# Access Compliance Report

## Public Rights-of-Way

### (Curb Ramps)

Intersection ID: 18210	Main Street: E_WOODLAWN_RD	Cross Street: BRANDYWINE_RD	Location: E
ADA ID: 4B0876DBE3C8	Ramp Type: BlendTrans2	Initial Pass/Fail: Fail	Overall Compliance: No
			Severity Score: 21.25

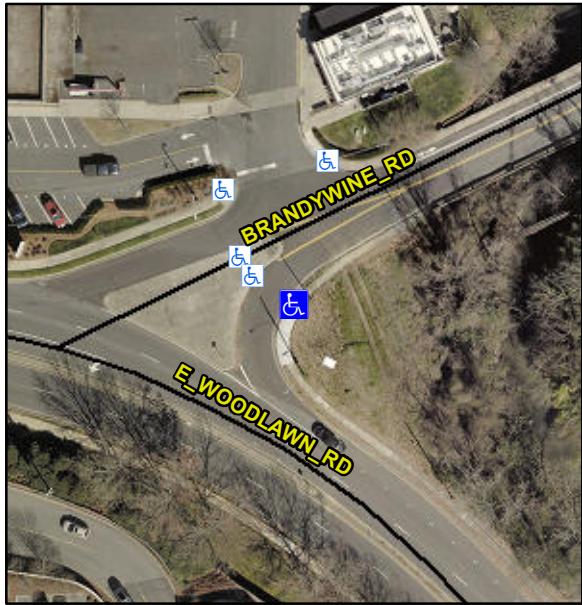
Codes/Mitigation Info/Possible Solution			Field Measurements/Component Compliance					
	Possible Solutions:		Compliance	Description	Data	Compliance	Description	Data
	Remove & Replace Curb Ramp With Two New Directional Ramps or Equivalent.		N/A	Ramp Length (in)	78.0	Yes	BlendTrans Slope (%)	1.3
			No	Ramp Width (in)	43.0	No	BlendTrans XSlope (%)	6.8
			N/A	Flare Type LT	N/A	N/A	Flare Type RT	N/A
			N/A	Flare Slope LT (%)	N/A	N/A	Flare Slope RT (%)	N/A
			N/A	Flare Traversable LT?	N/A	N/A	Flare Traversable RT?	N/A
			N/A	Landing Length (in)	N/A	N/A	DWS Provided?	N/A
			N/A	Landing Width (in)	N/A	N/A	DWS Contrast?	N/A
			N/A	Landing Slope (%)	N/A	N/A	DWS Length (in)	N/A
			N/A	Landing X Slope (%)	N/A	N/A	DWS Full Width?	N/A
Surveyor Notes:			N/A	Landing Curb? (Y/N)	N/A	N/A	DWS Offset (in)	N/A
PROW/ADA:			N/A	Shared Landing?	N/A			
R304.5.1, R304.5.3			N/A	Gutter Ponding?	N/A	N/A	Gutter Slope (%)	N/A
			N/A	Gutter Lip Ht (in)	N/A	N/A	Gutter X Slope (%)	N/A
